Commonwealth Edison

Subject: Response to IE Bulletin 80-08,
concerning "Examination of Containment
Liner Penetration Welds"
Dresden Station Units 1, 2, and 3;
Quad Cities Station Units 1 and 2;
Zion Station Units 1 and 2;
LaSalle County Station Units 1 and 2;
Byron Station Units 1 and 2; and
Braidwood Station Units 1 and 2
NRC Docket Nos. 50-10/237/249,
50-254/265, 50-295/304, 50-373/374,
50-454/455, and 50-256/457

Enclosure
Commonwealth Edison Company
Response to IE Bulletin 80-08

TYPICAL PENETRATION DETAIL

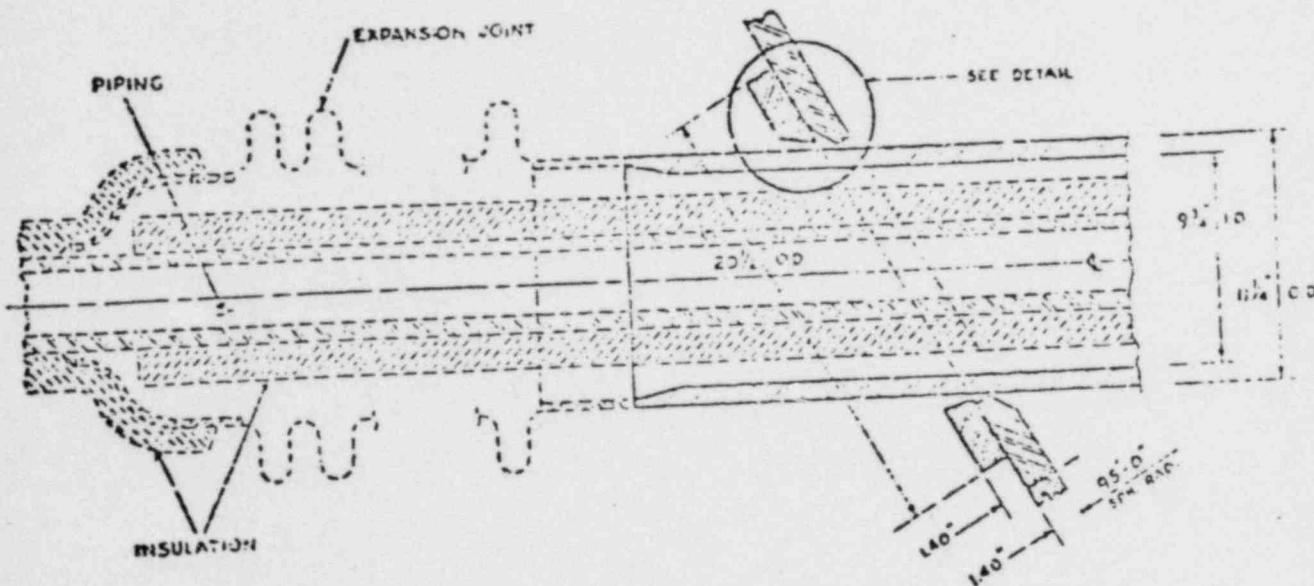
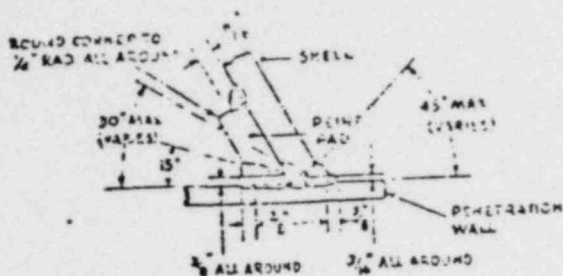
1. Reactor enclosure penetrations do not use the flued head design. A typical penetration detail is attached. Review of this detail does, however, exhibit apparent containment boundary butt welds between the penetration sleeve and the process pipe similar to that shown as item (e) in Fig. NE-1120-1 (attached).
2. There are eleven (11) sphere penetrations utilizing expansion bellows. The original Code of Construction was ASA B31.1-1955 (Section I), including 1956 Addenda.
3. Drawings indicate butt welds with backing rings were used for fabrication. We have not been able to locate records describing the type of nondestructive examinations used or their results.

We will review penetration design and determine the feasibility of performing radiographic examinations prior to unit startup.
